4. TITLE AND SUBTITLE
ONPOST/OFFPOST GROUND/SURFACE WATER MONITORING PROGRAM, TASK 44, FINAL
TECHNICAL PLAN

ENVIRONMENTAL SCIENCE AND ENGINEERING
DENVER, CO8. PERFORMING ORGANIZATION
REPORT NUMBER

ROCKY MOUNTAIN ARSENAL (CO.). PMRMA
COMMERCE CITY, CO10. SPONSORING/MONITORING
AGENCY REPORT NUMBER

8.1 GROUND_WATER	8-1
8.2 SURFACE_WATER	8-4
9.0 REFERENCES	9-1
APPENDIX A--COMMENTS AND RESPONSES TO THE DRAFT FINAL TECHNICAL PLAN, NOVEMBER 1987	
APPENDIX B--TASK 44 FINAL LETTER TECHNICAL PLAN, FEBRUARY 10, 1988 AND COMMENTS AND RESPONSES TO THE DRAFT FINAL LETTER TECHNICAL PLAN, APRIL 29, 1987

Figure 4

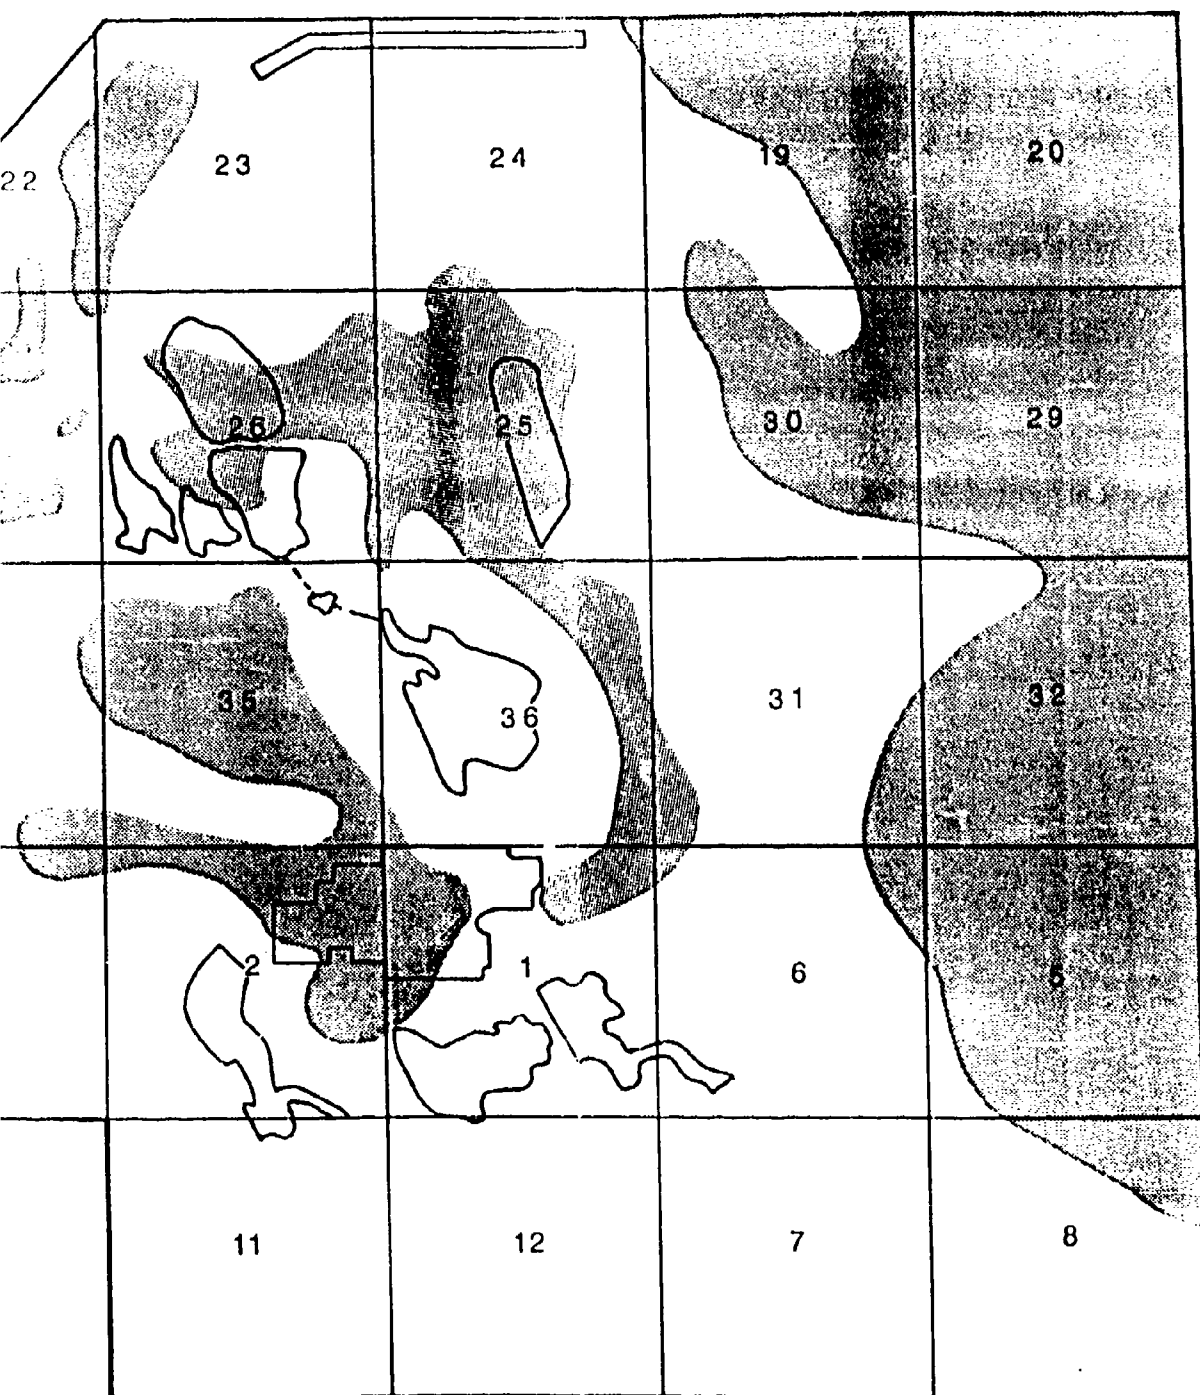
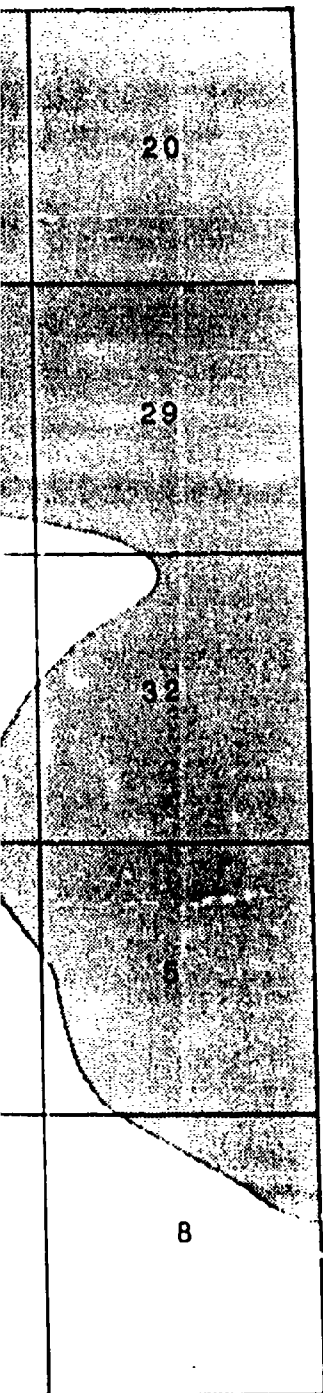
Figure 4: Does the saturated alluvium map represent a wet, dry, or average year? Both the high and low water table conditions need to be considered to insure unbiased selection of wells in areas where water level fluctuations produce periodic saturation of alluvial sediments.

The approximate areal extent of unsaturated alluvium presented in Figure 4 was constructed by modifying the unsaturated alluvium map presented in the Final Report, Selection of Contaminant Control Strategy for Rocky Mountain Arsenal (RMACCPMT, 1983). Modifications were made based on the results of the Task 4 water-quantity survey which consisted of four quarters of water-level measurement data. In general, the boundaries of unsaturated alluvium shown in Figure 4 were defined by wells periodically found to be dry during Task 4. Areas depicted as saturated contain Task 4 wells found to contain water consistently throughout the duration of Task 4. However, this map will be revised as additional data are generated and as further hydrogeologic interpretations are made.

Figure 5
PREFERRED BEDROCK PALEOCHANNELS

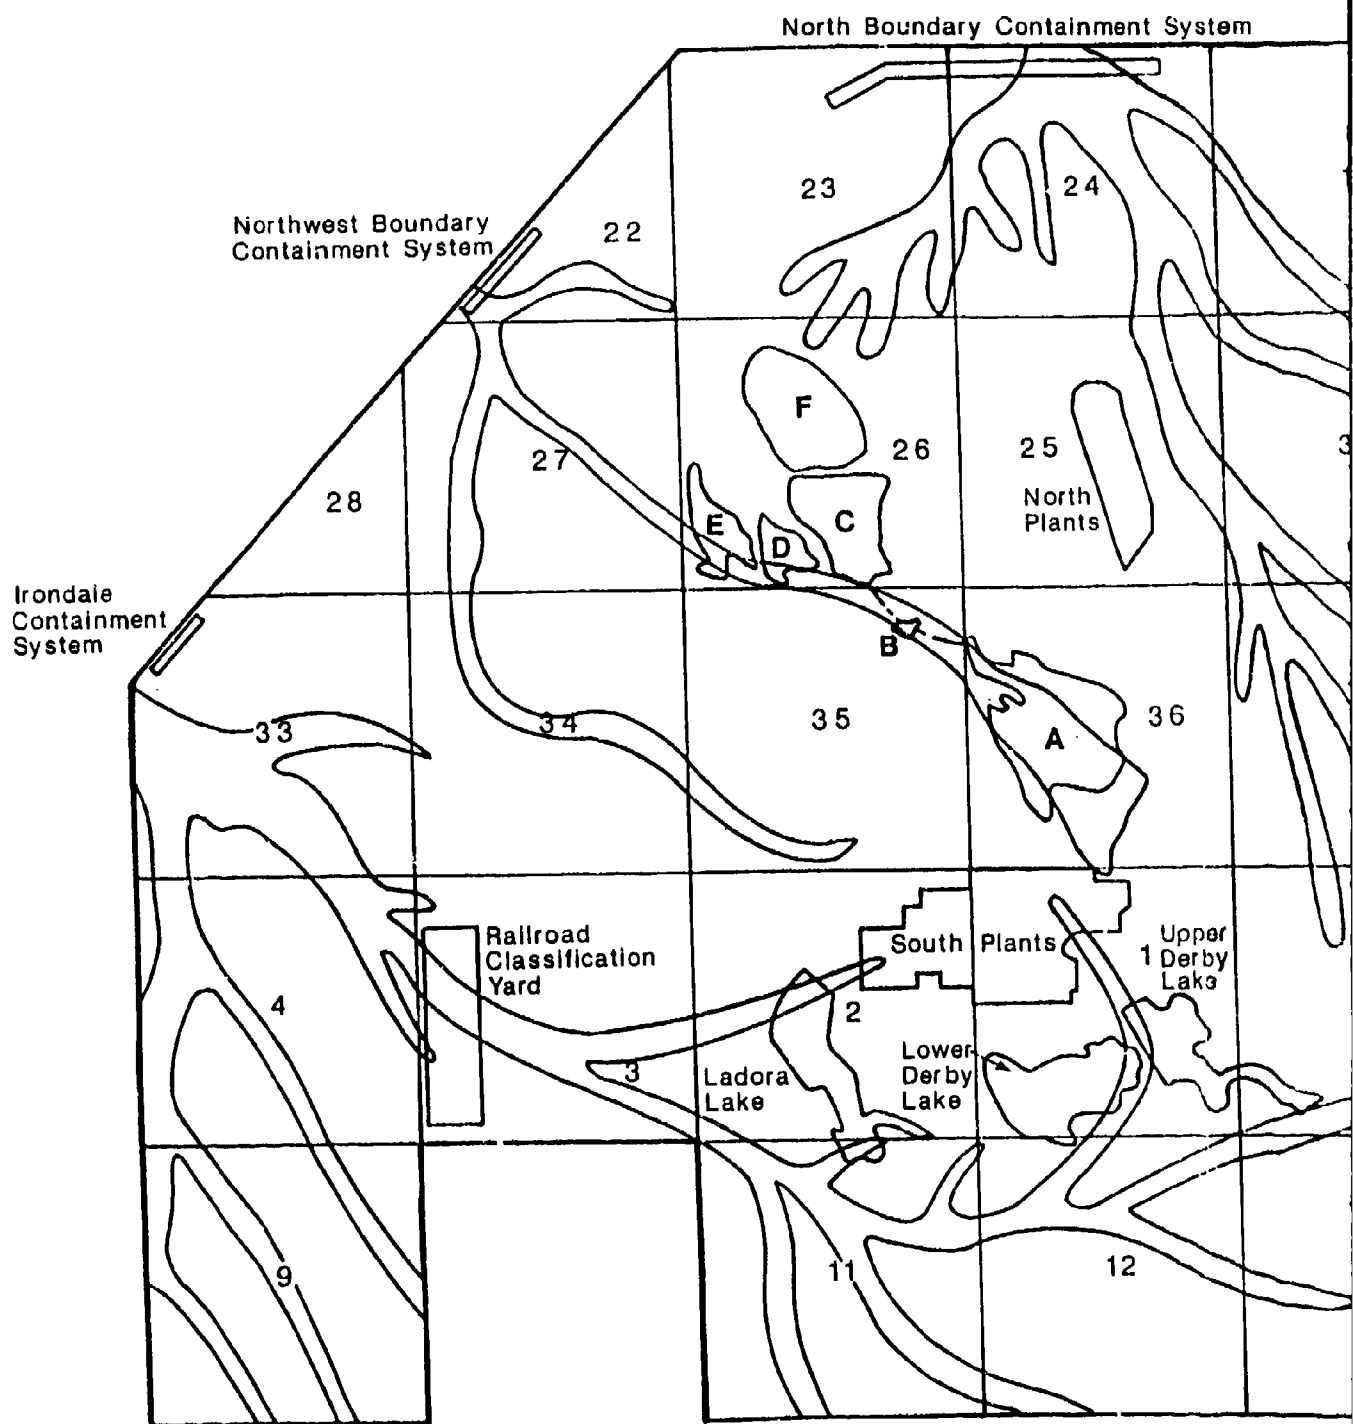
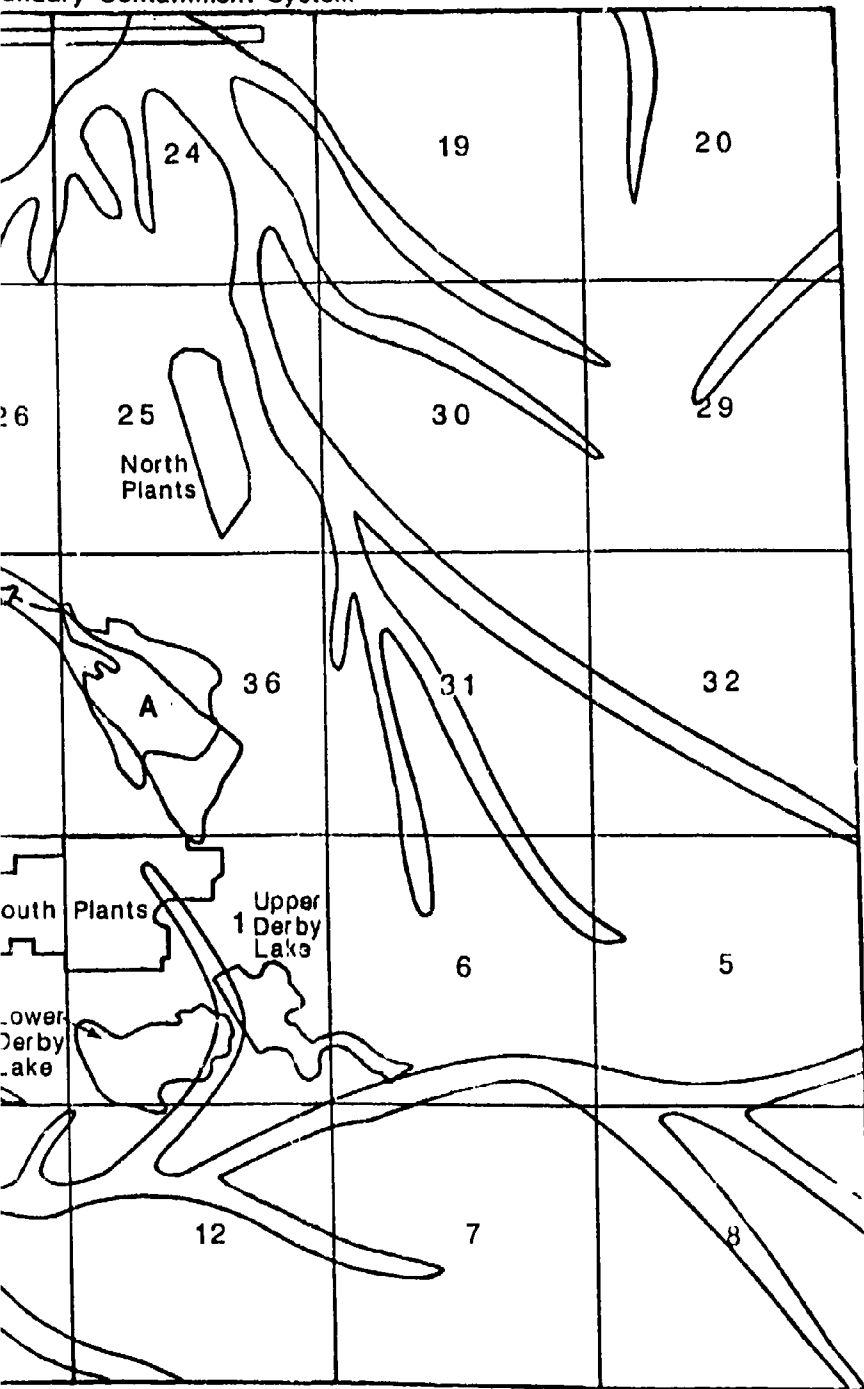
Page 11, Figure 5: The inferred bedrock paleochannel map correlates well with the MKE interpretation, with the exception of Section 34. Drilling conducted in 1986 by MKE indicates that the small channel originating in Section 35 is not continuous through Section 34. The channel picks up again in the northwest quarter of Section 34.

The locations of inferred paleochannels shown on Figure 5 were established based on available geologic and hydrogeologic information. This map will be updated and revised accordingly as Task 44 interpretations are completed. These interpretations will incorporate data generated under Tasks 25, 26, 38, 39, and 44 and Shell investigations. Please refer also to our response to CDRI Specific Comment 14.

Figure 6
DOMINANT ALLUVIAL GROUND
WATER FLOW DIRECTIONS

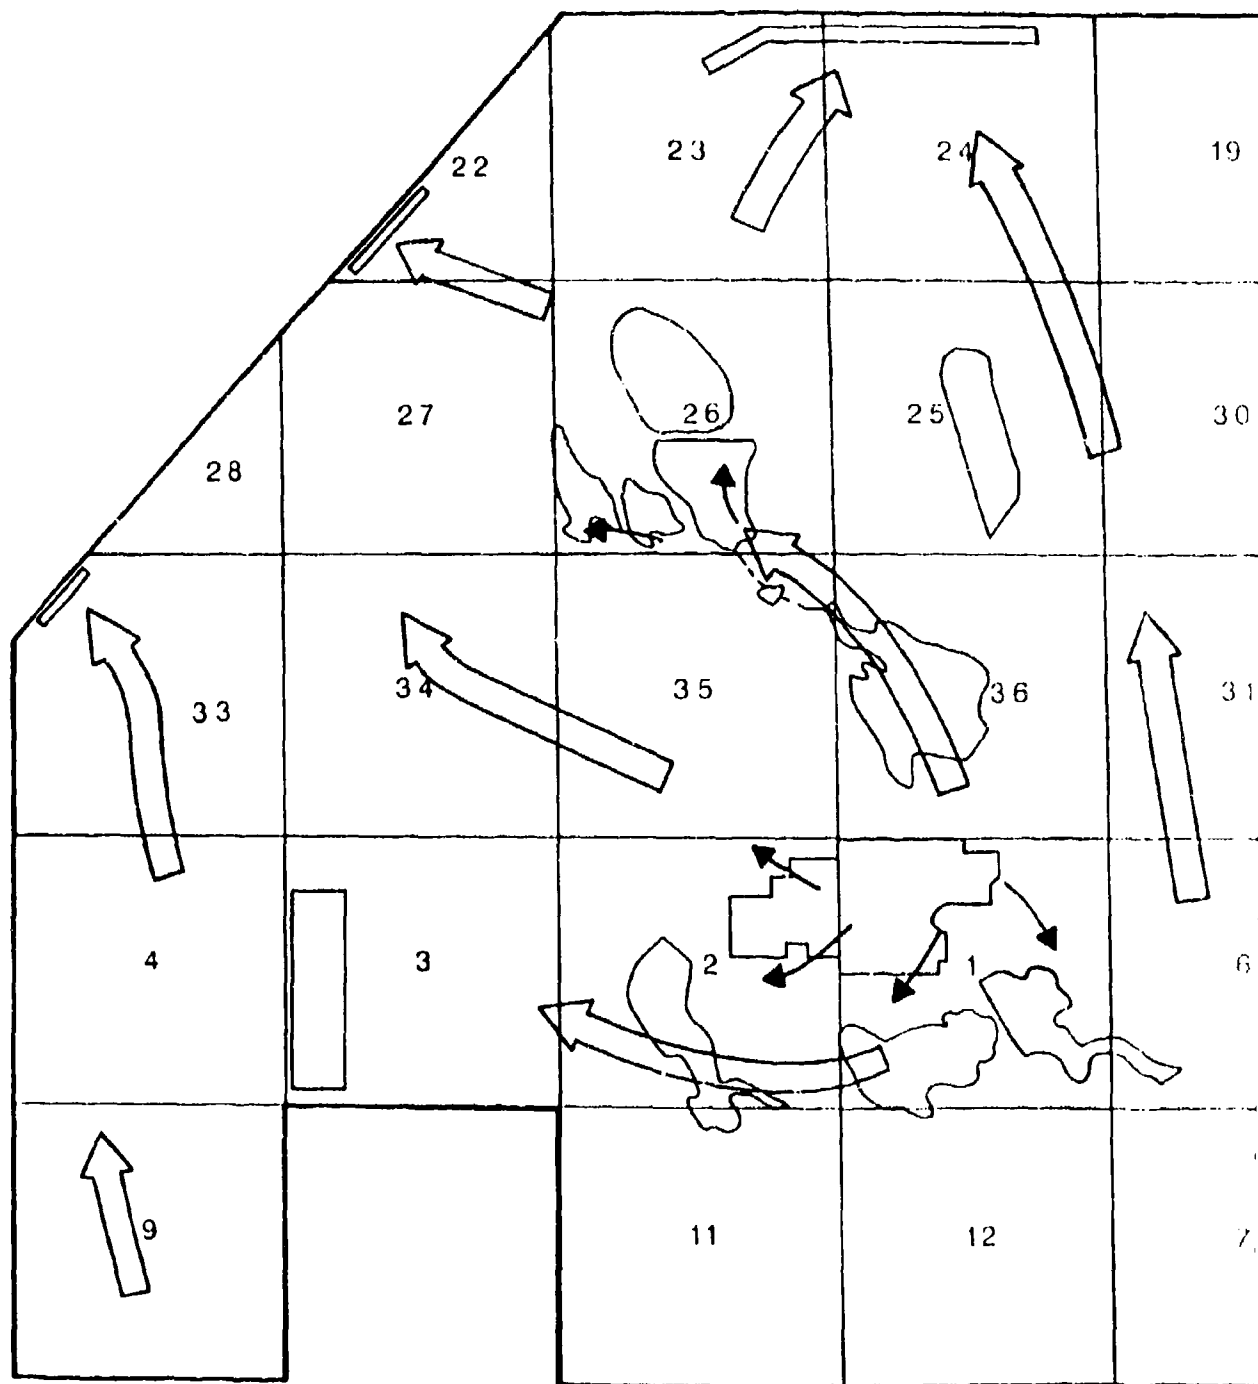
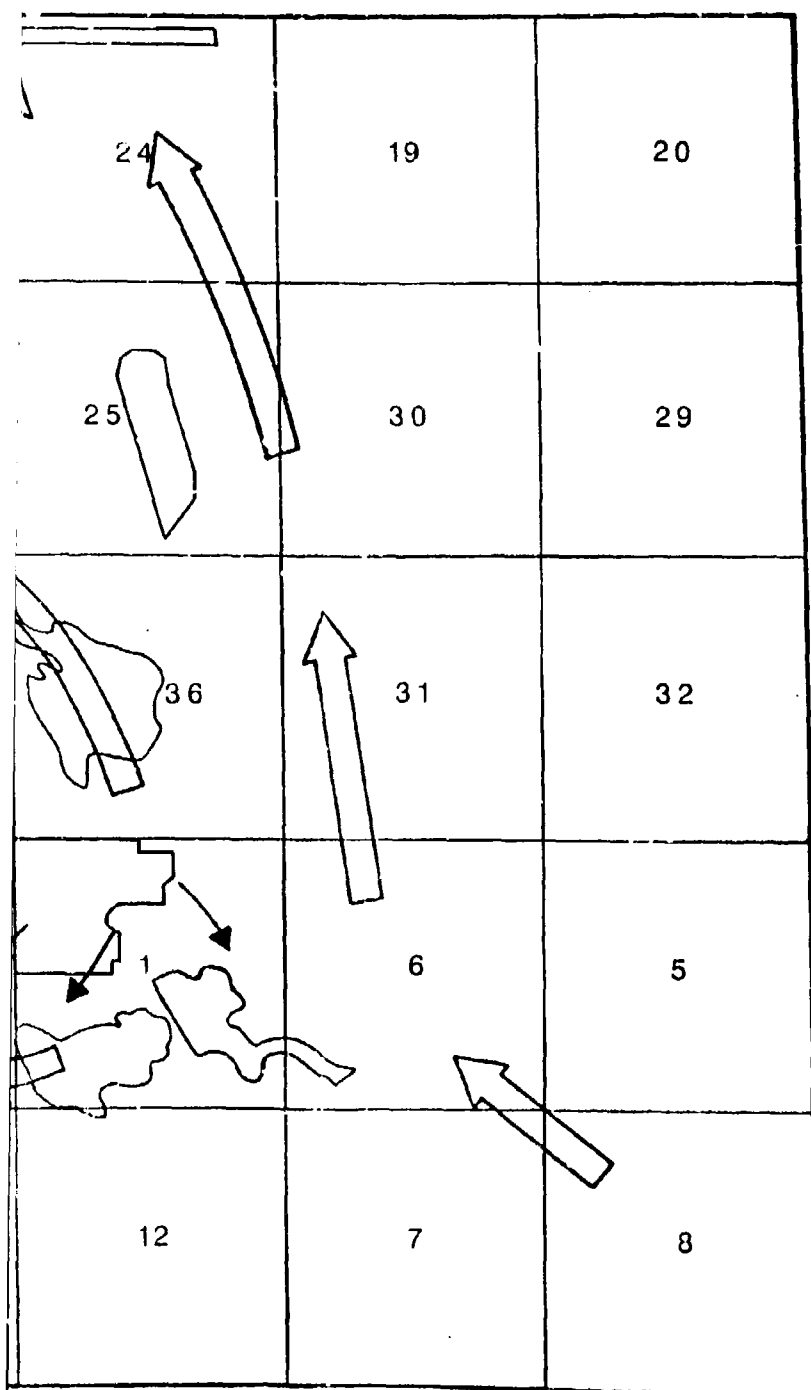
P.12 Figure 6. Regional and localized groundwater flow should not be represented using subjective arrows that appear to identify the locations of the three operating boundary systems. A potentiometric surface contour map would be more useful to demonstrate the uppermost groundwater flow directions.

The ground-water flow directions presented in Figure 6 were drawn based on previous hydrogeologic investigations (May 1982) and on recent water-table contour maps (Task 4). A map showing ground-water flow directions and water-table contours will be presented in the Task 44 Technical Plan.

Ground-water flow directions shown on Figure 6 are based on the results of previous RMA hydrogeologic studies (May 1982) and recent (Task 4) water table contour maps. Flow directions were not drawn with inference to any previously identified contaminant distributions. Therefore, it would be inappropriate to depict the movement of DBCP contamination from the Rail Classification Yard to the Irondale Containment System as a localized ground-water flow direction in Figure 6.
